1 INTRODUCTION

1.1.1 Prime Transport Planning Ltd (Prime) have been provided with comments from Wrexham County Borough Council (WCBC) Highways Development Control dated 16th December 2019. These comments were made in relation to the Transport Assessment (TA) prepared in support of an outline planning application (ET/DC/P/2019/0877) for a proposed commercial development located off Oak Road on Wrexham Industrial Estate (WIE). The development has an access point onto Oak Road. The parcel of land comprises B1 and B2/B8 usage, totalling 21,700sqm, broken down into:

THE OAKS, WREXHAM INDUSTRIAL ESTATE

**SWEPT PATH ANALYSIS - ACCESS
ALL MOVEMENTS**

P19014-003B

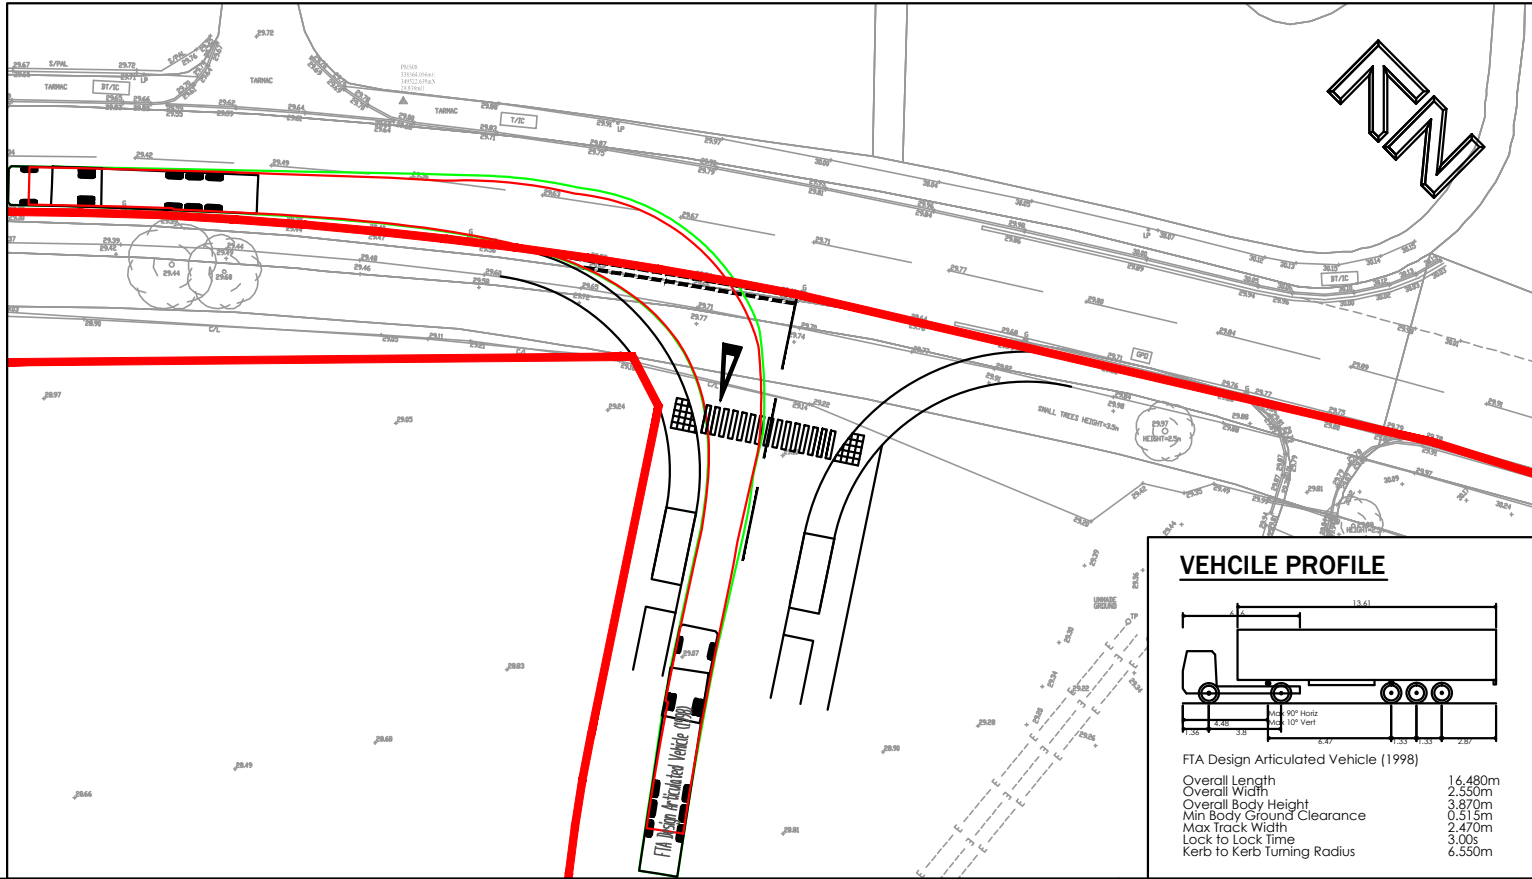
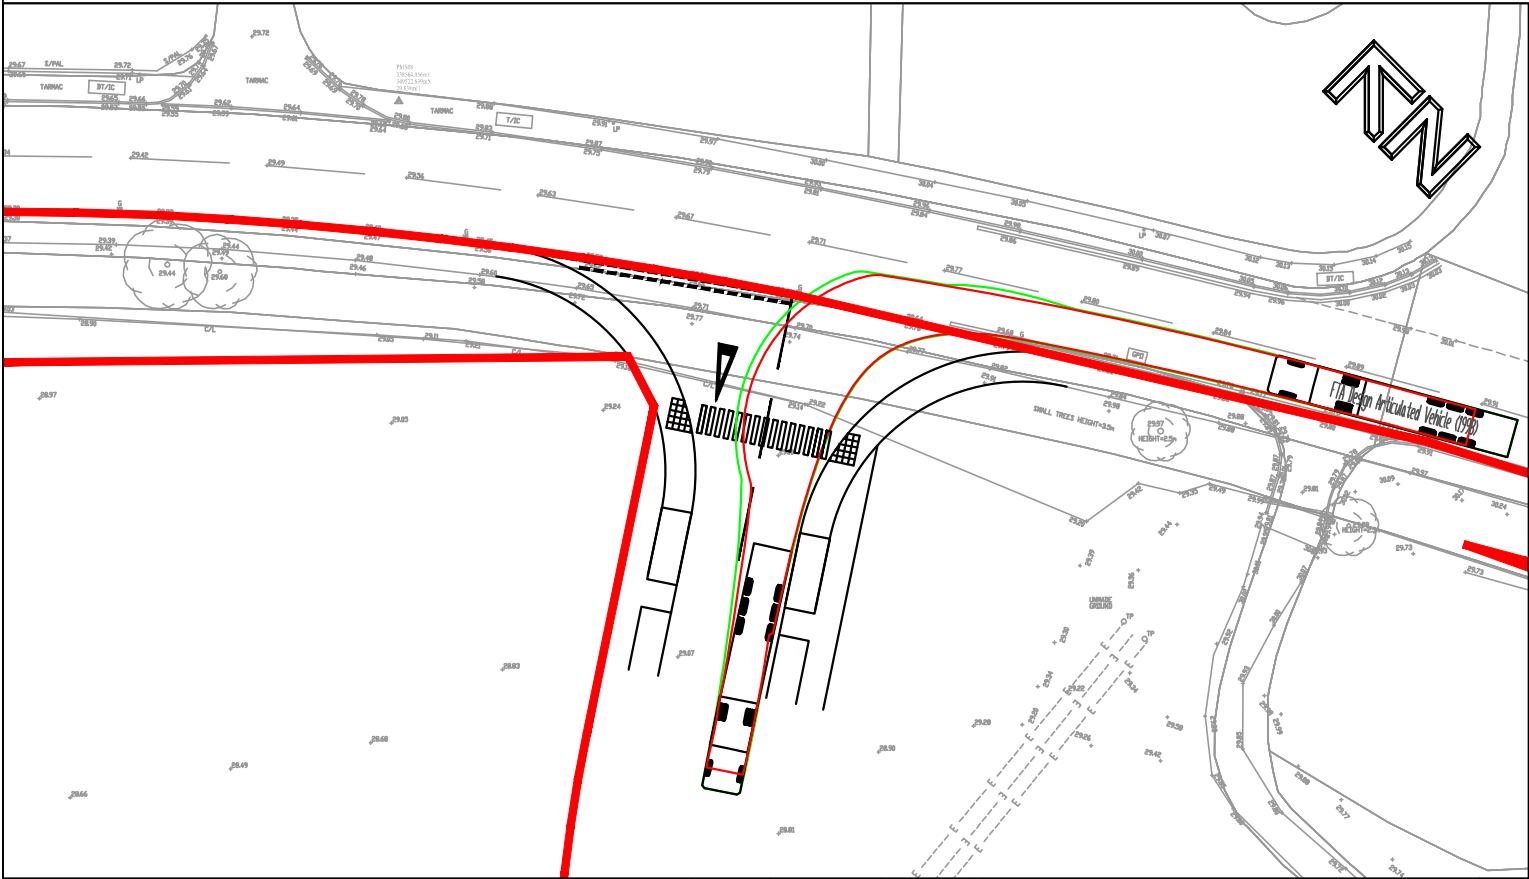
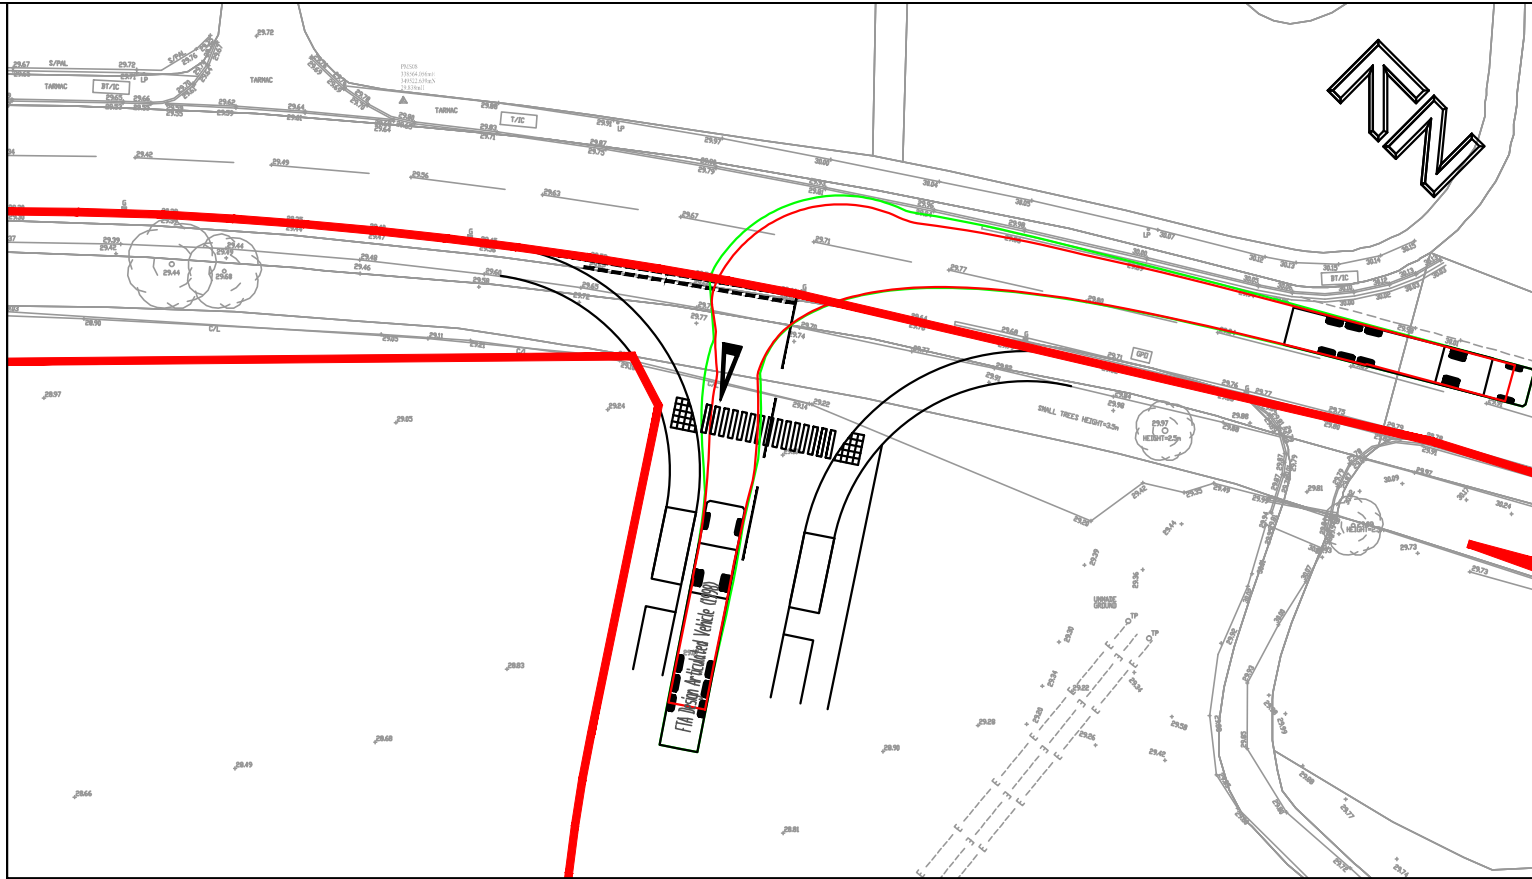
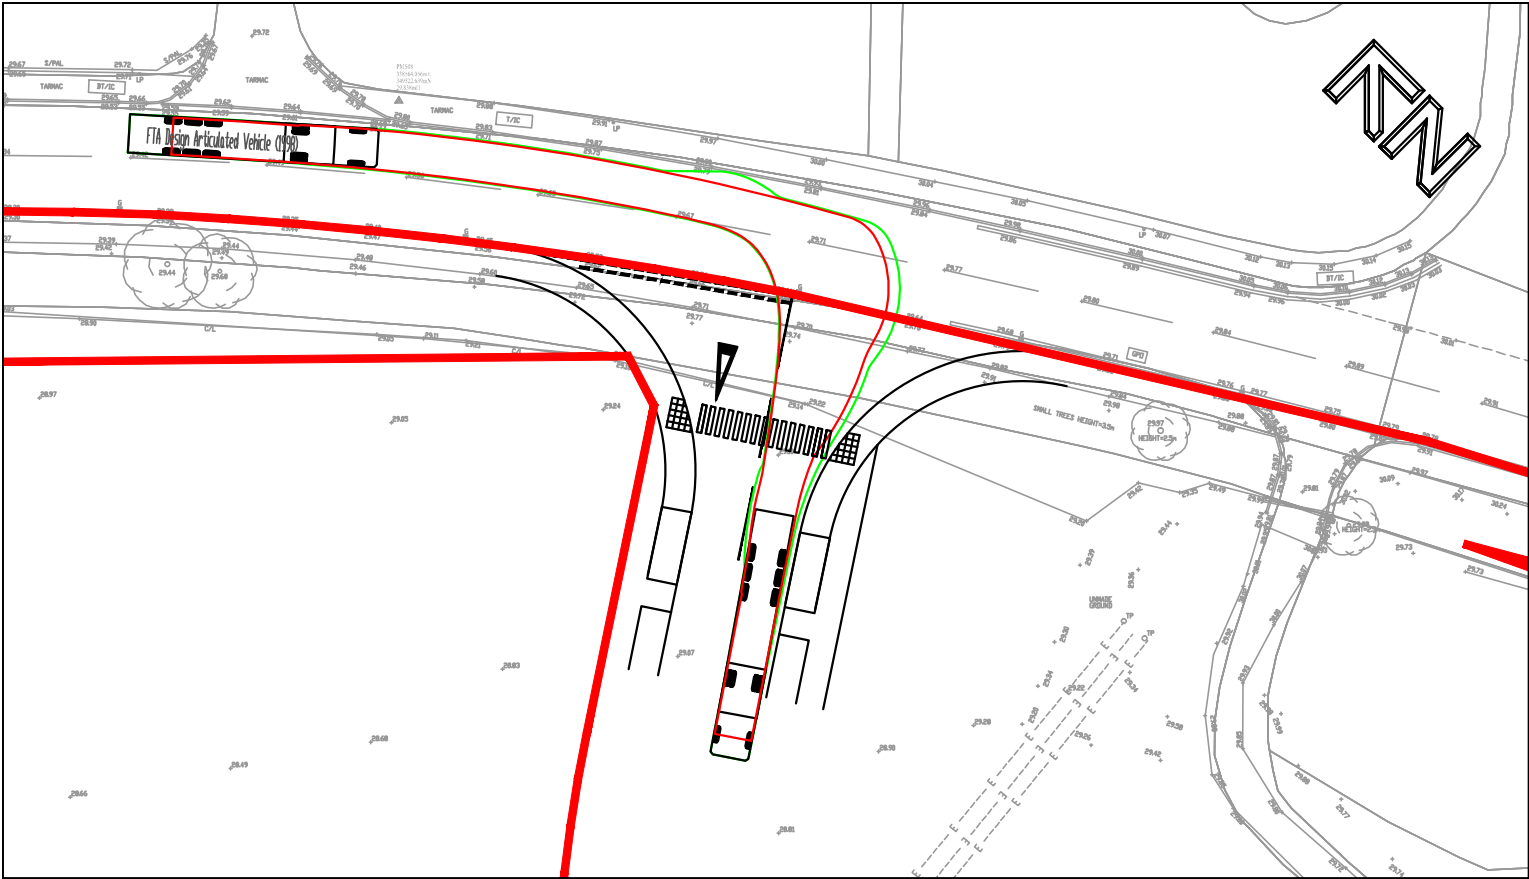
- 2.1.6 *Point 2 – I would recommend the provision of a suitable pedestrian crossing / splitter island across the proposed access. The proposed crossing indicated on submitted layout plan (Drg. No. P19014-003) is not considered suitable. This feature is setback too far into the proposed access and is unlikely to be used by pedestrians walking along this side of Oak Road. Revised swept path details will be required to demonstrate that HGVs can access the site without interfering with any revised pedestrian crossing facility in this location*
- 2.1.7 We believe that a given the relatively low levels of traffic likely to be generated by the proposed development and the low levels of pedestrian activity in the vicinity of the site, that a pedestrian crossing comprising dropped kerbs and tactile paving is the appropriate solution to incorporate into the design of the proposed site access.

- 2.1.9 The highway officers' comments have been noted however, and the crossing point has been moved 12m north. This new location can be seen within **Drawing P19014-003B** in **Appendix I** of this Technical Note. The crossing point is acknowledged as being more in line with the natural pedestrian desire line.

B	14.02.20	AM	PEDESTRIAN CROSSING POINT MOVED WCBC COMMENTS & REVISED SITE BOUNDARY
A	16.10.19	VB	
Rev	Date	By	Revision notes
